METROPOLITAN DEVELOPMENT COMMISSION
HEARING EXAMINER

Case Number:	2025-CPL-857 / 2025-CVR-857
Property Address:	9450 Counselors Row (Approximate Address)
Location:	Washington Township, Council District #4
Petitioner:	Keystone Witness, LLC, by Brian J. Tuohy
Zoning:	C-S
Request:	Approval of a Subdivision Plat, to be known as 9450 Counselor's Row, dividing 7.61 acres into two lots. Variance of Development Standards of the Consolidated Zoning and Subdivision Ordinance to provide for a proposed hotel with a building height of 74 feet (maximum 45 feet permitted), a maximum front yard setback of 135 feet (maximum 85-foot front yard setback required), parking space stall size of nine-foot by 18-foot, or 162 square feet (minimum nine-foot by 18-foot, or 180 square-foot required), and a Green Factor Score of 0.087 (minimum Green Factor Score of 0.22 required).
Waiver Requested:	None
Current Land Use:	Hotel and parking lot
Staff Reviewer:	Marleny Iraheta, Senior Planner

Site Plan

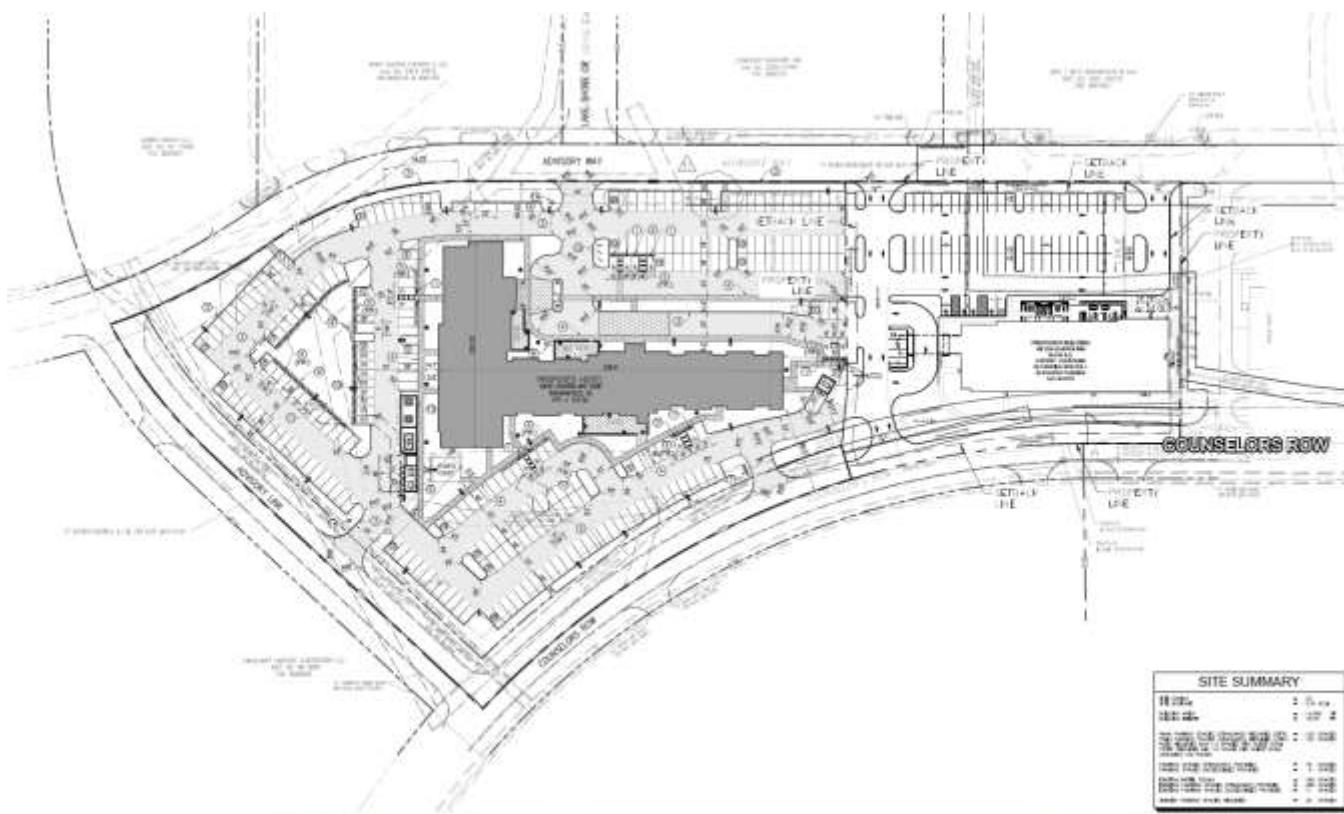
The maximum front setback is 85 feet, but the allowance of an increased front setback would ensure sufficient parking is proposed on site, which staff would support. The parking stall sizes would be supportable so long as the required ADA parking spaces meet the 20-foot length requirement.

Staff would note that sidewalks are not shown on the submitted site plan. The Ordinance would require sidewalks to be constructed around the site's perimeter, with the development of the property.

Staff **recommends approval** of the height, setback, and parking space sizes with the condition that the ADA parking spaces meet the 20-foot length requirement.

Landscape Plan

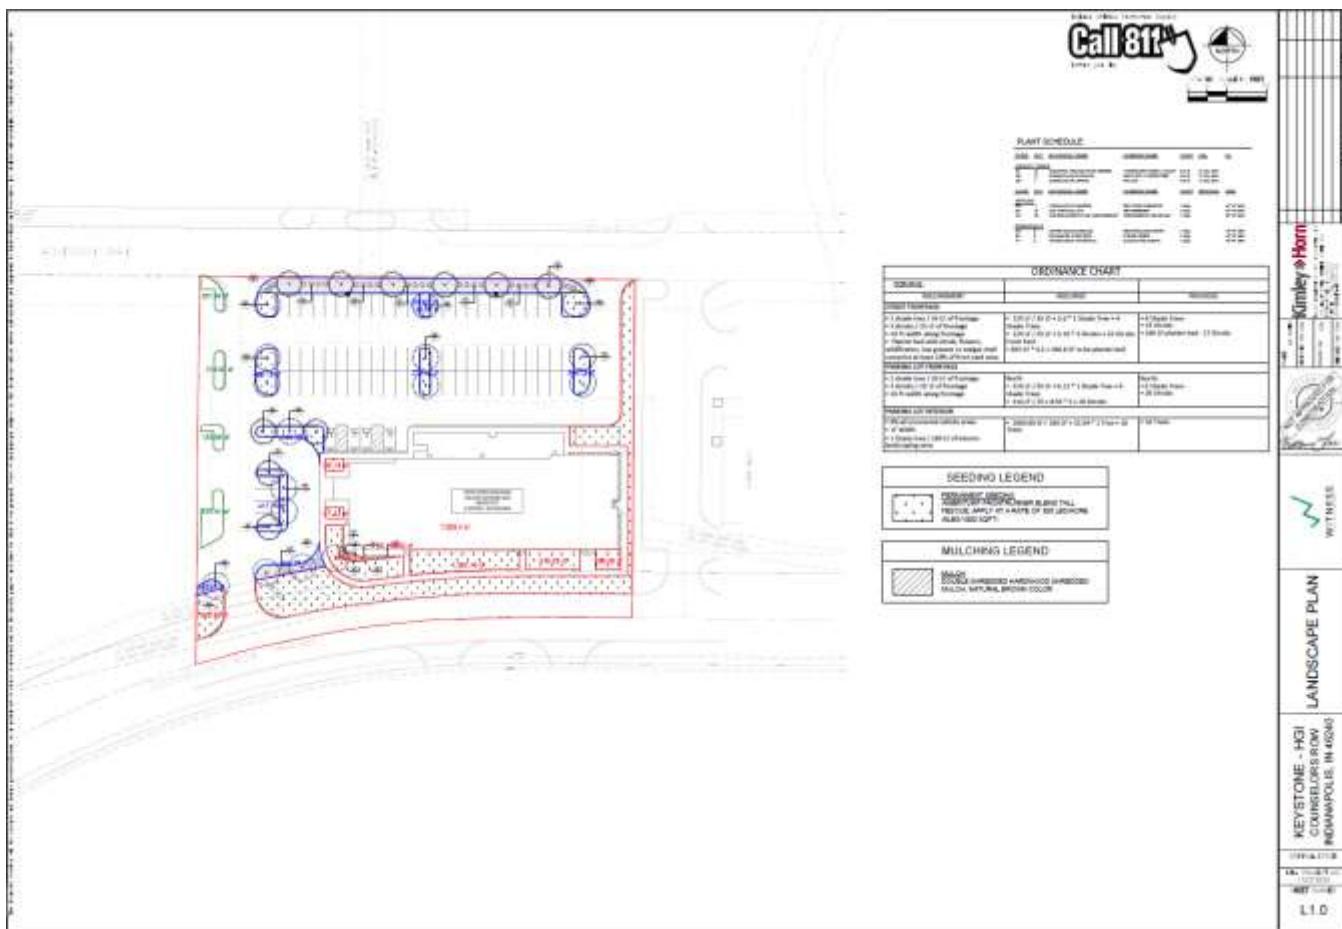
Staff would not support the Green Factor Score reduction since the allowance of a height variance should provide more land area for landscaping. Because the required landscaping on site would be deficient, the option to reduce the building height and reduce the number of hotel rooms would create a reduction in total parking spaces since they coincide with the room count.

Staff **recommends denial** of the Green Factor Score variance.
